UNITED STATES PATENT AND TRADEMARK OFFICE

| APPLICATION NO. | FILING DATE | FIRST NAMED INVENTOR | ATTORNEY DOCKET NO. | CONFIRMATION NO. |
|-----------------|-------------|--------------------------|---------------------|------------------|
| 10/628,190 | 07/28/2003 | Neil Lawrence Weisenfeld | NW-1 | 6087 |

| Office Action Summary | Application No. 10/628,190 | Applicant(s) WEISENFELD, NEIL LAWRENCE | |

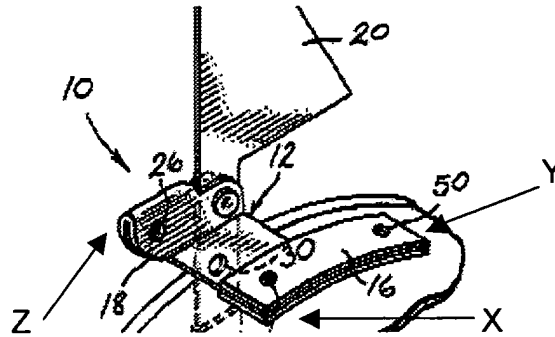
Pieszchala discloses a device comprising a substantially U-shaped member (18) comprising on one leg of said U-shaped member the support portion (16) with opposing end

tabs (X, Y, see below) and on the other leg of said U-shaped member a shield member (Z, see below),

an elongated indicator arm (14) disposed interiorly of said U-shaped member (Figure 3), being rotatably connected to said U-shaped member, said elongated indicator arm being rotatable from a first position to a second position in which said indicator arm is disposed substantially perpendicular to said first position (Figures 3 & 4). Furthermore, it has been held that a recitation with respect to the manner in which a claimed apparatus is intended to be employed (i.e. "being capable of engaging one of the plurality of equally spaced parallel slots" in claim 1; "for use with a hanging folder" in claim 2; "for attaching said support portion to a folder" in claim 7) does not differentiate the claimed apparatus from a prior art apparatus satisfying the claimed structural limitations. **Ex parte Masham**, 2 USPQ2d 1647 (1987).
